Re: Case No. 24-0794-EL-BTA
In the Matter of the Amendment Application of AEP Ohio Transmission Company, Inc. for a Certificate of Environmental Compatibility and Public Need for the Vigo - Pine Ridge Switch 138 kV Transmission Line Project

**Application for Amendment #3 to the
VIGO - PINE RIDGE SWITCH 138 kV
TRANSMISSION LINE PROJECT**

OPSB CASE NO. 24-0794-EL-BTA

The purpose of Amendment #3 is to document the changes to the right-of-way (“ROW”) widths at certain spans along the Preferred Route since the OPSB’s approval of the Preferred Route, and to seek OPSB approval of the revised ROW widths. This Amendment #3 application does not provide updated information for the Alternate Route because the purpose of this amendment is to document the changes to ROW widths on the Preferred Route alignment that have been made since the OPSB’s approval of the Preferred Route.

EXHIBIT 1: Summary of Engineering Adjustments for ROW Width Increases

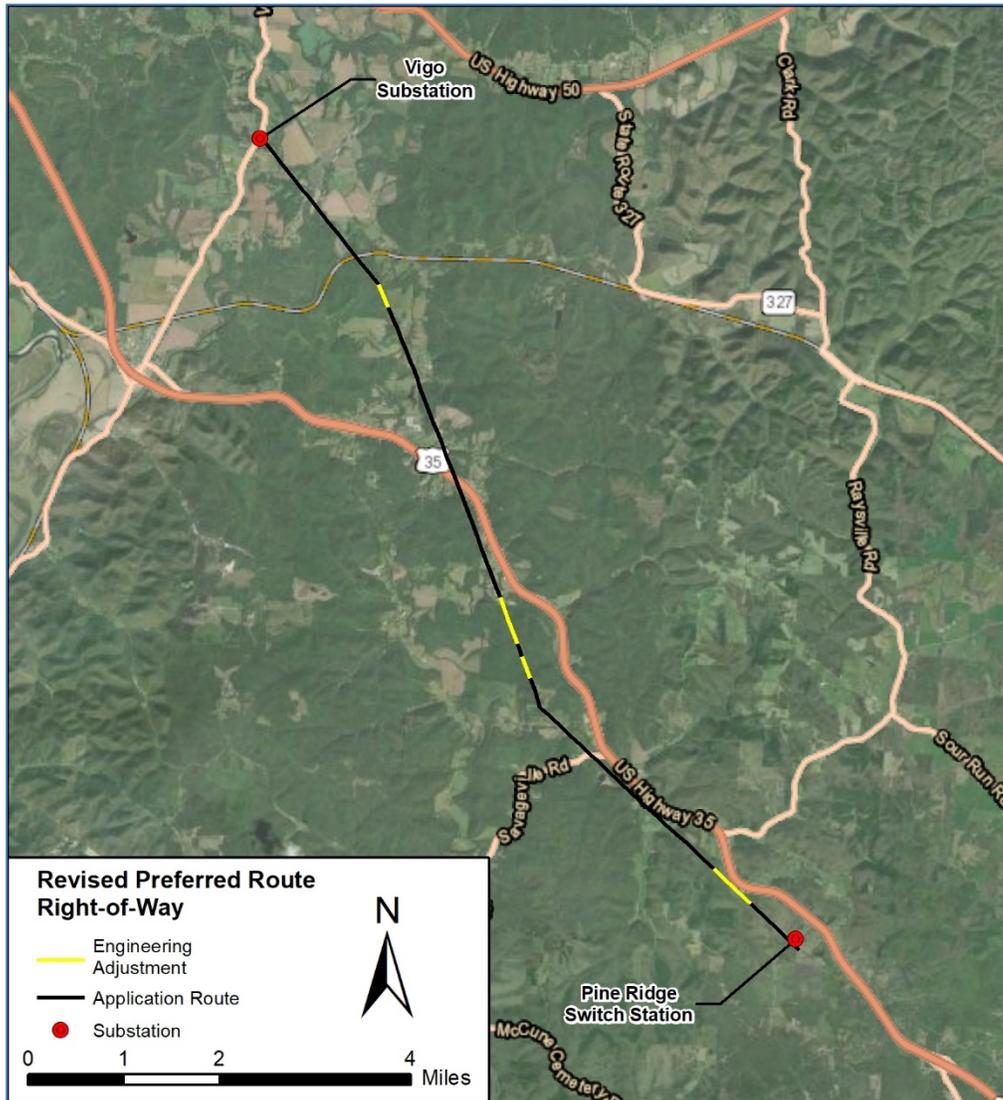
Six engineering adjustments were made along the OPSB-approved Preferred Route as shown in **Exhibit 1**. These engineering adjustments were made due to the need to increase the width of the transmission ROW to meet blowout requirements in order to safely operate the transmission line at 138 kV in the future, as local and regional electrical demand increases. By widening the ROW at these spans, the Company can remove trees that pose a risk to maintaining safe, reliable electrical service to their customers. These engineering adjustments are described in detail below in the series of **Exhibits 2 through 4**. The ROW has been widened at six spans, with the ROW being widened between ten and thirty feet.

Structure Spans	Approved ROW Width (ft)	Proposed ROW Width (ft)	Easement Agreement/Option Obtained (Yes/No)
104 – 105	100	110	Yes
128 – 129	100	120	Yes
129 – 130	100	120	Yes
131 – 132	100	110	Yes
152 – 153	100	130	Yes
153 – 154	100	120	Yes

EXHIBIT 2: Map Illustration of Engineering Adjustments (Structures 104 to 105)

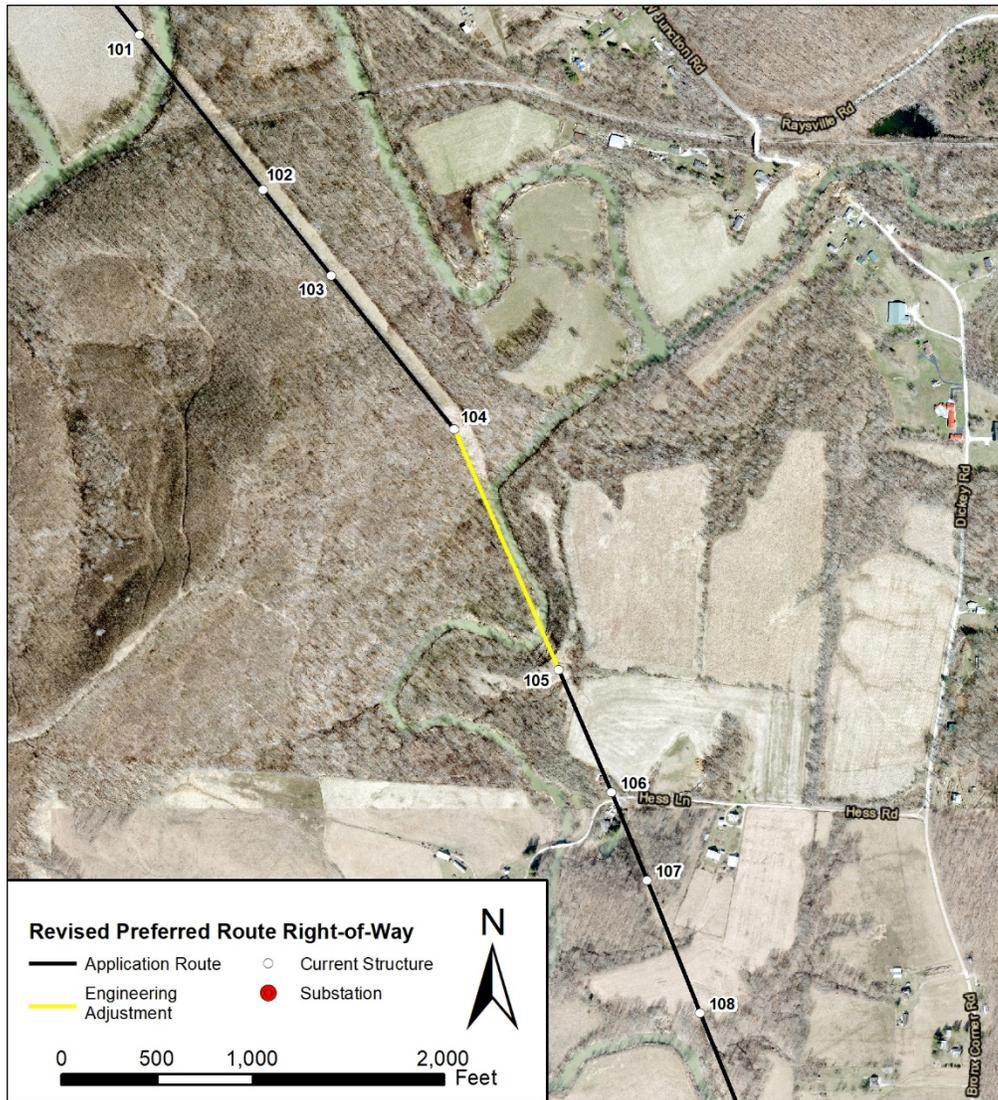
The original permanent easement was acquired at a width of 100 feet for the Vigo-Pine Ridge Transmission line from Vigo Station to the Pine Ridge Switch. Following completion and placing of the line into service, a subsequent engineering review of the line determined that additional ROW width is needed for the line span from Structure 104 to Structure 105 to meet the blowout requirements to operate the line at 138 kV in the future. Therefore, the ROW has widened to a total of 110 feet (an additional five feet added on each side of the ROW).

EXHIBIT 3: Map Illustration of Engineering Adjustments (Structures 128 to 130 and Structures 131 to 132)

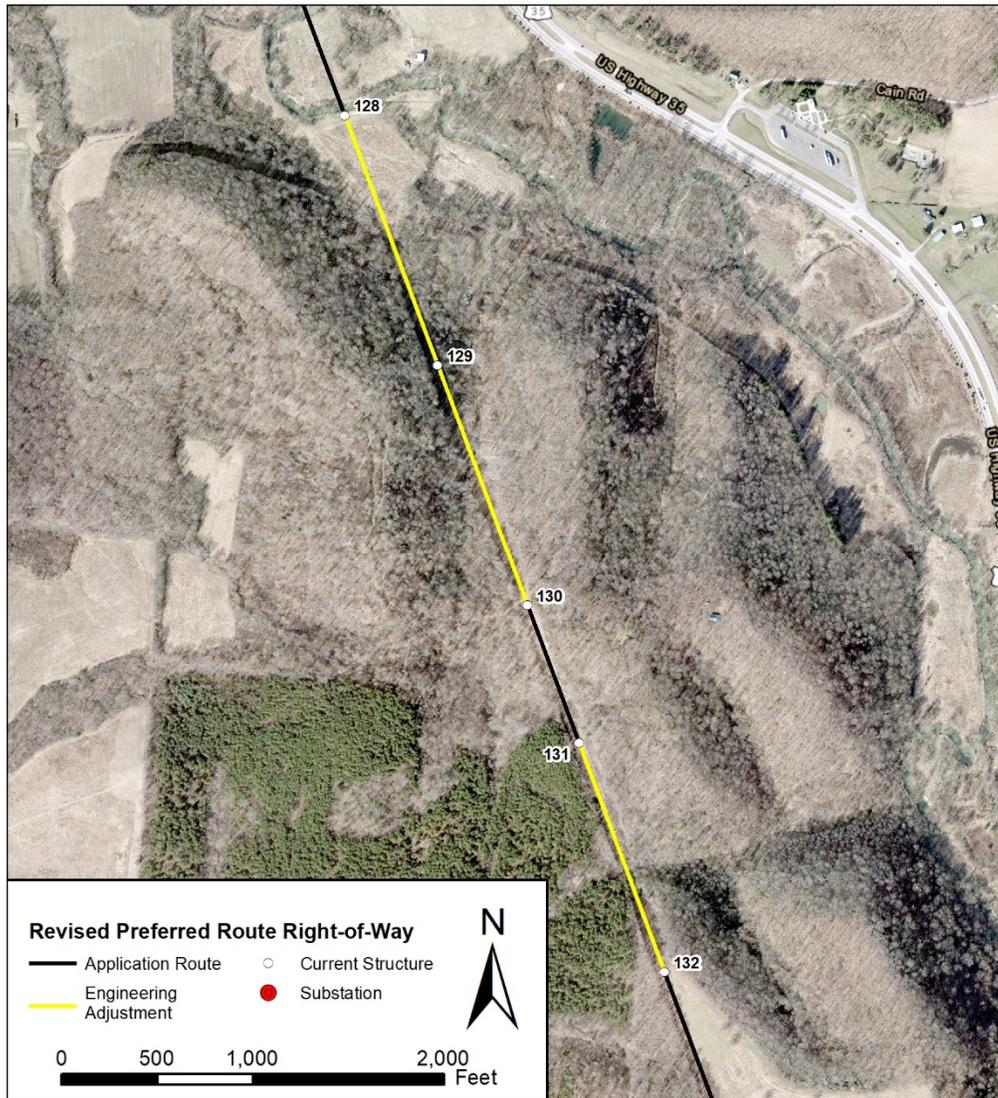
The original permanent easement was acquired at a width of 100 feet for the Vigo-Pine Ridge Transmission line from Vigo Station to the Pine Ridge Switch. Following completion and placing of the line into service, a subsequent engineering review of the line determined that additional ROW width is needed for the line span from Structure 128 to Structure 129, Structure 129 to Structure 130, and from Structure 131 to Structure 132 to meet the blowout requirements to operate the line at 138 kV in the future. For the spans from Structure 128 to Structure 129, and from Structure 129 to Structure 130, the ROW has widened to a total of 120 feet (an additional ten feet added on each side of the ROW). For the span from Structure 131 to Structure 132, the ROW has widened to a total of 110 feet (an additional five feet added on each side of the ROW).

EXHIBIT 4: Map Illustration of Engineering Adjustments (Structures 152 to 154)

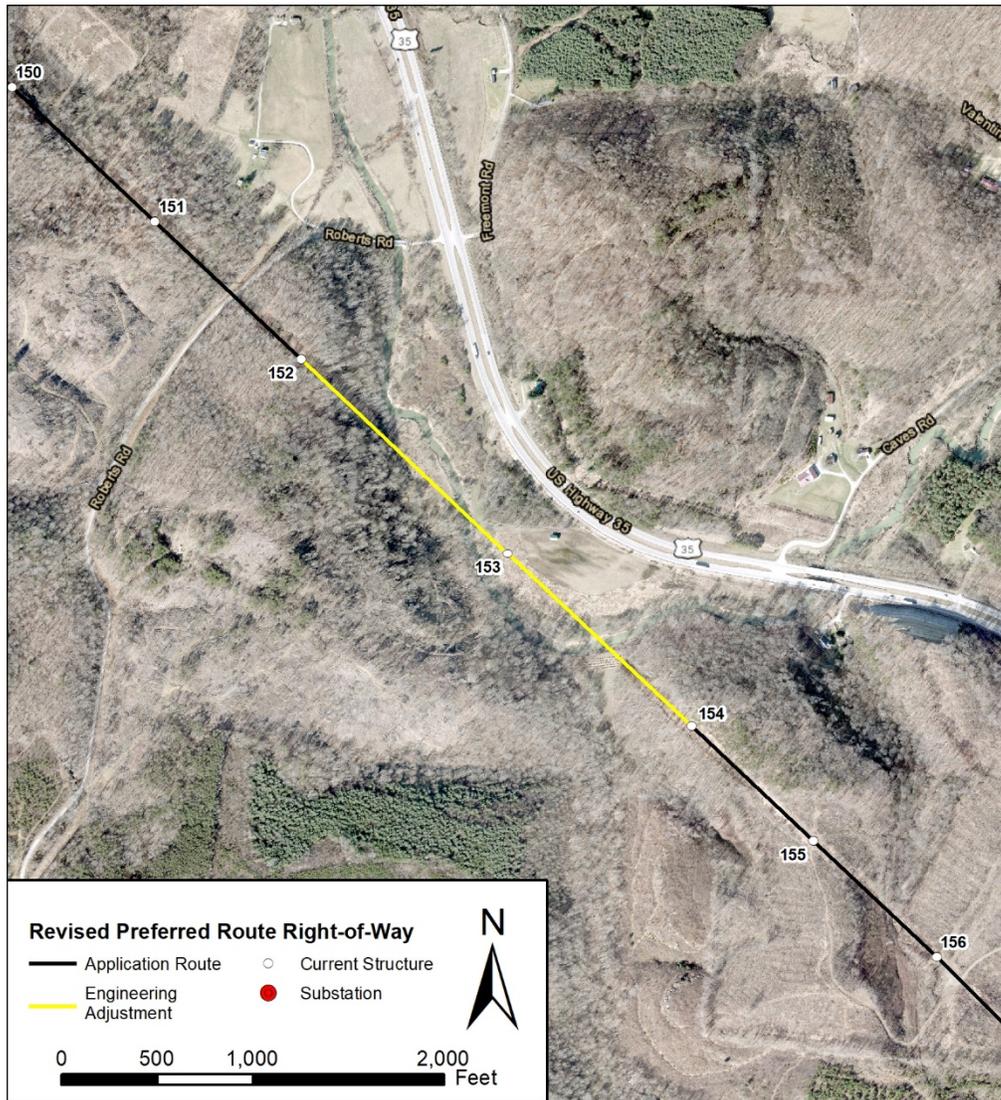
The original permanent easement was acquired at a width of 100 feet for the Vigo-Pine Ridge Transmission line from Vigo Station to the Pine Ridge Switch. Following completion and placing of the line into service, a subsequent engineering review of the line determined that additional ROW width is needed for the line span from Structure 152 to Structure 153, and from Structure 153 to Structure 154 to meet the blowout requirements to operate the line at 138 kV in the future. For the span from Structure 152 to Structure 153, the ROW has widened to a total of 130 feet (an additional fifteen feet added on each side of the ROW). For the span from Structure 153 to Structure 154, the ROW has widened to a total of 120 feet (an additional ten feet added on each side of the ROW).
